Bayside Planning Panel

Item No	5.3
Application Type	Development Application
Application Number	DA-2017/236
Lodgement Date	9 January 2017
Property	20 Dunmore Street, North Bexley
Owner	Mr O Maksymow and Mrs V Maksymow
Applicant	Excell Design Consultants
Proposal	Alterations and additions to the Heritage item "Fairmont Aged Care Centre" including a front balcony, ensuites to existing rooms and extension to the rear
No. of Submissions	One (1)
Cost of Development	\$341,000
Report by	Marta Gonzalez-Valdes – Coordinator Major Assessments

Planning Assessment Report

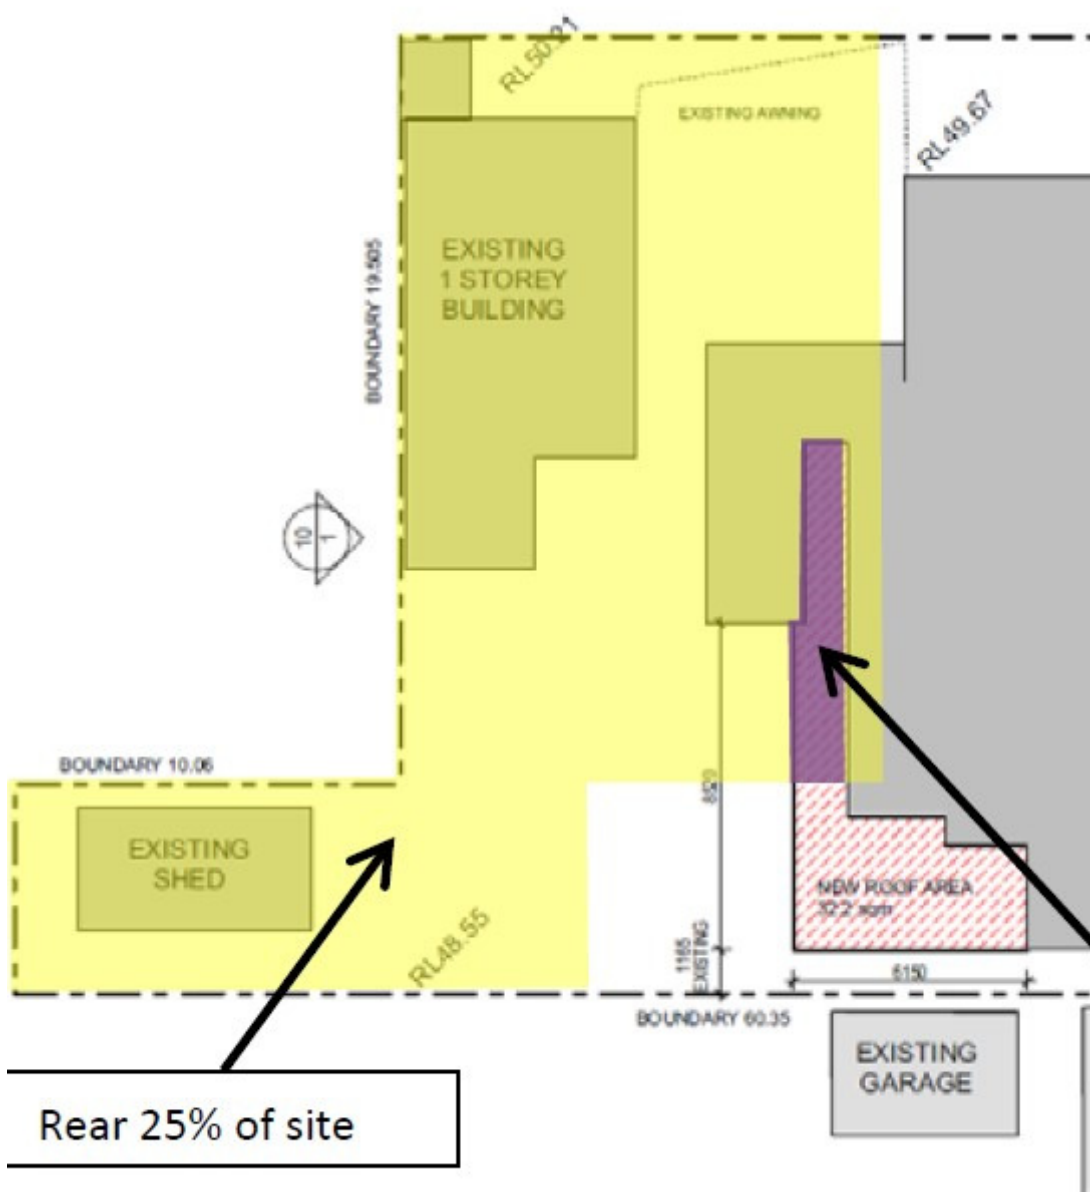
The proposed extension at first floor level encroaches into the 25% rear setback (as shown in purple below in diagram submitted by the applicant), therefore, the proposal does not comply with clause 40(c) of the SEPP, which requires that the height of the building within the 25% rear of the site be single storey.

The applicant's submission has addressed the matters outlined in subclause (3) and is supported in the context of clause 4.6. Applying the principles established in *Four2Five Pty Ltd v Ashfield Council* [2015] NSWLEC 90 it is considered that the development will be in the public interest as it is consistent with the objectives of the development standard in clause 40(c) of the SEPP and the objectives for development within the R2 zone.
